**STAFF REPORT
KETCHUM PLANNING AND ZONING COMMISSION
MEETING OF JULY 16, 2026**

PROJECT:	Greyhawk Townhomes
FILE NUMBER:	P26-008
APPLICATION TYPE:	Preapplication Mountain Overlay Design Review
PROPERTY OWNER:	Andrew Seligson & Sarah Toral
ARCHITECT:	Mike Allaire, AIA, Michael Doty Associates Architects
REQUEST:	Preapplication Mountain Overlay Design Review for the construction of two three-story duplex buildings and associated site improvements
LOCATION:	Tax Lot 6866 (RPK4N170140730), on the north side of Warm Springs Road at the western edge of the Ketchum city limits
ZONING:	General Residential Low Density (GR-L)
OVERLAY:	Mountain Overlay and Avalanche Overlay Districts
REVIEWER:	Abby Rivin – Senior Planner
NOTICE:	A public hearing notice was mailed to all property owners within 300 feet of the project site on June 24, 2026. The notice was published in the Idaho Mountain Express on June 24, 2026. A notice was posted on the city's website on July 1, 2026 and on the project site on July 9, 2026.

BUILDING B - EXTERIOR ELEVATIONS

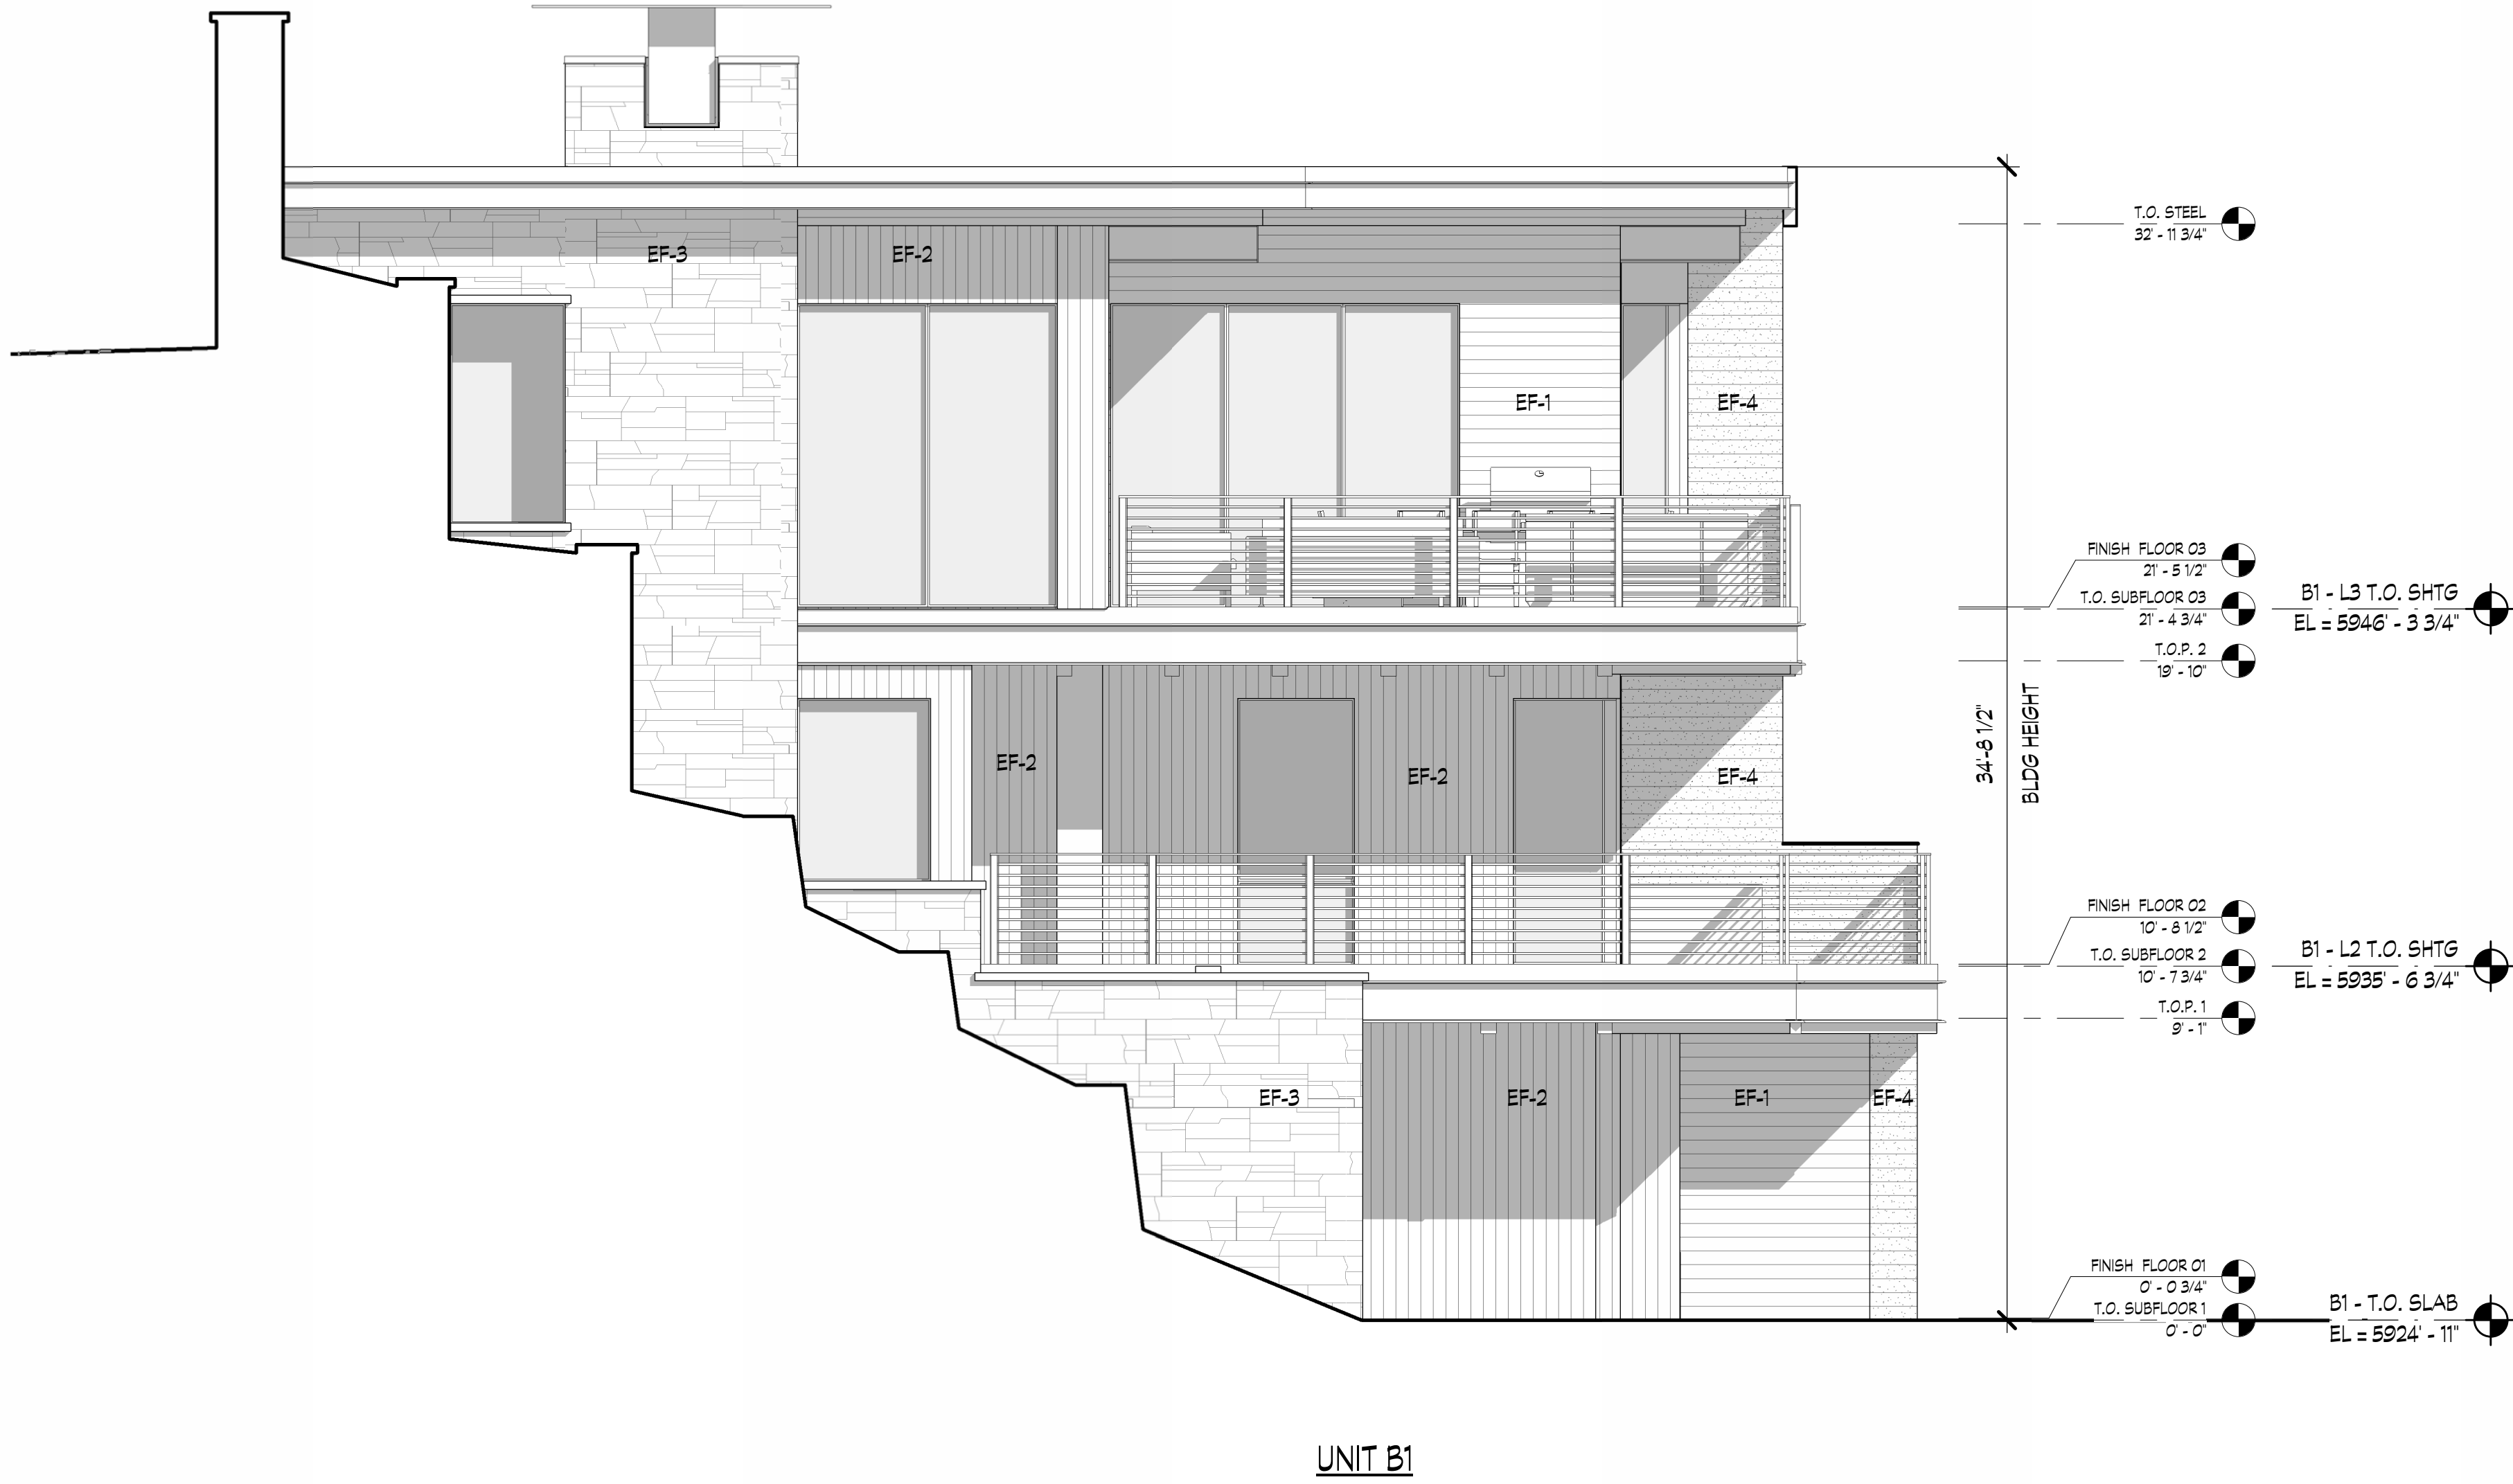
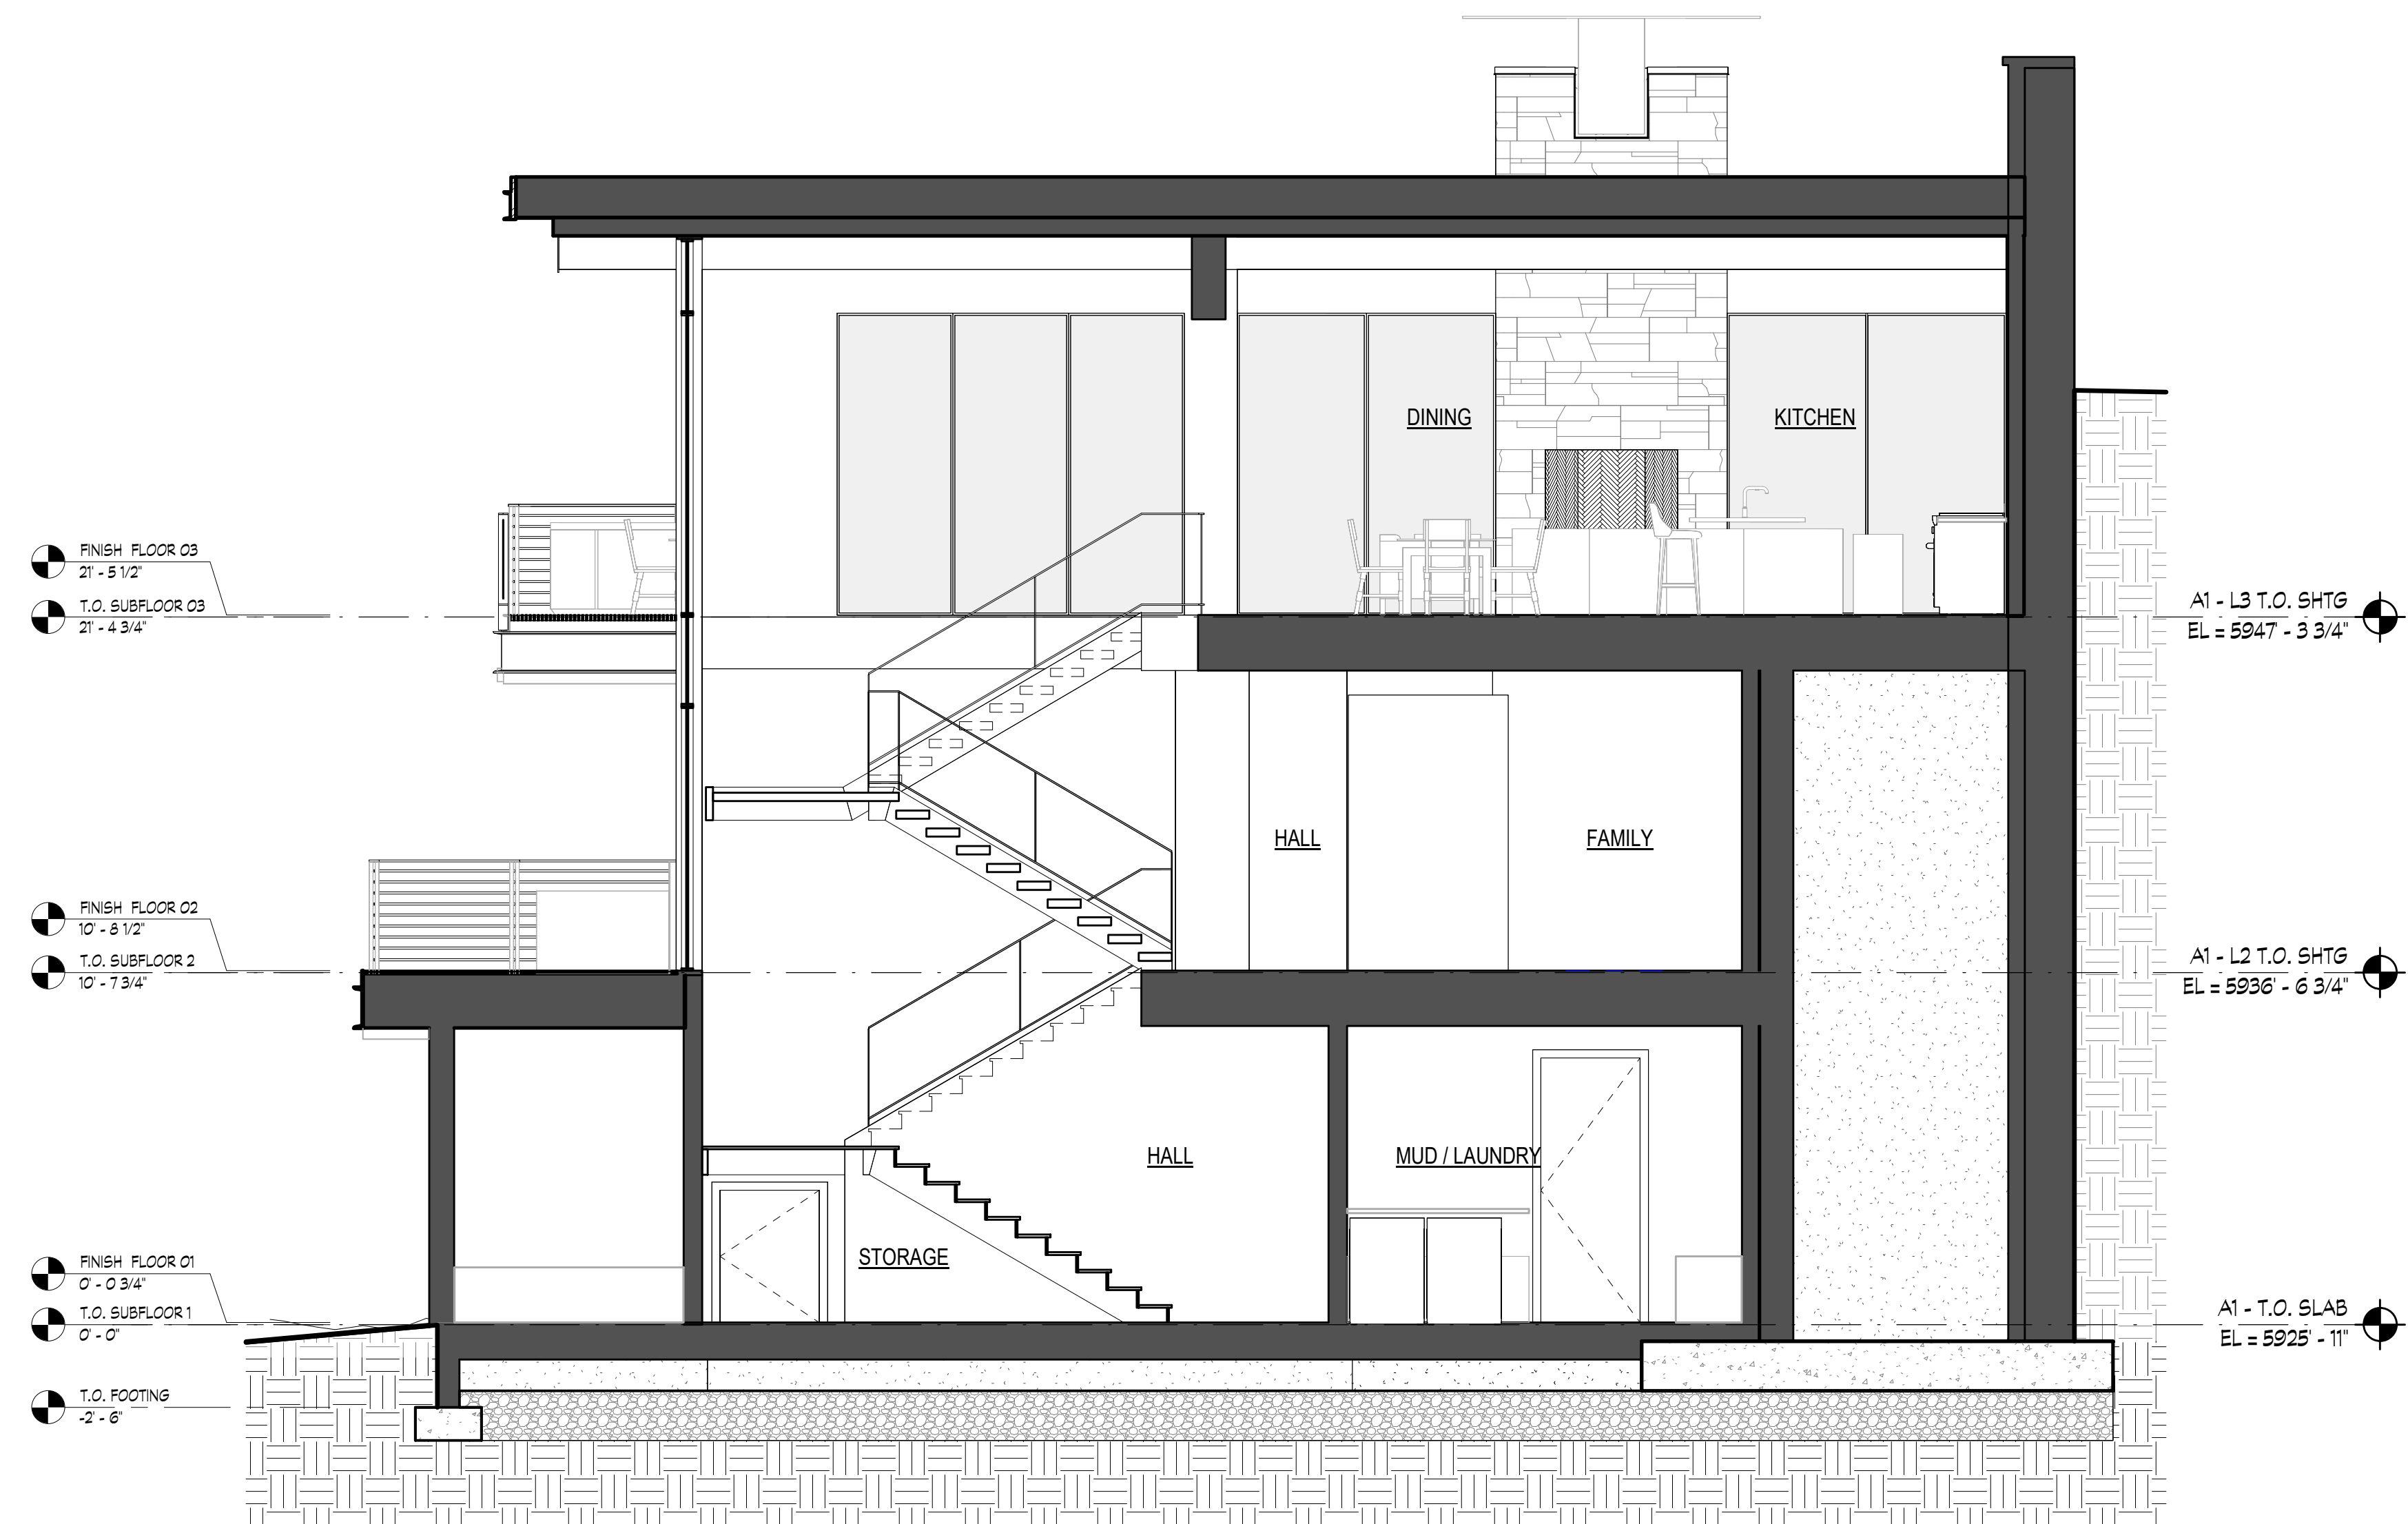
The submitted building elevations (Sheets A-312 and A-322) indicate that building height has been measured to the top of the flat roof. However, pursuant to the definition of Building Height in LDC §16.08.020, building height must be measured from the lowest of natural, existing, or finished grade to the highest point of the structure, including parapets and other roof elements. Based on the submitted plans, staff cannot verify compliance because the rear avalanche protective wall appears to be the highest point of the structure but is not included in the building height calculation. Prior to final Mountain Overlay Design Review, the applicant should revise the building height calculations to measure to the highest point of each structure in accordance with LDC §16.08.020.
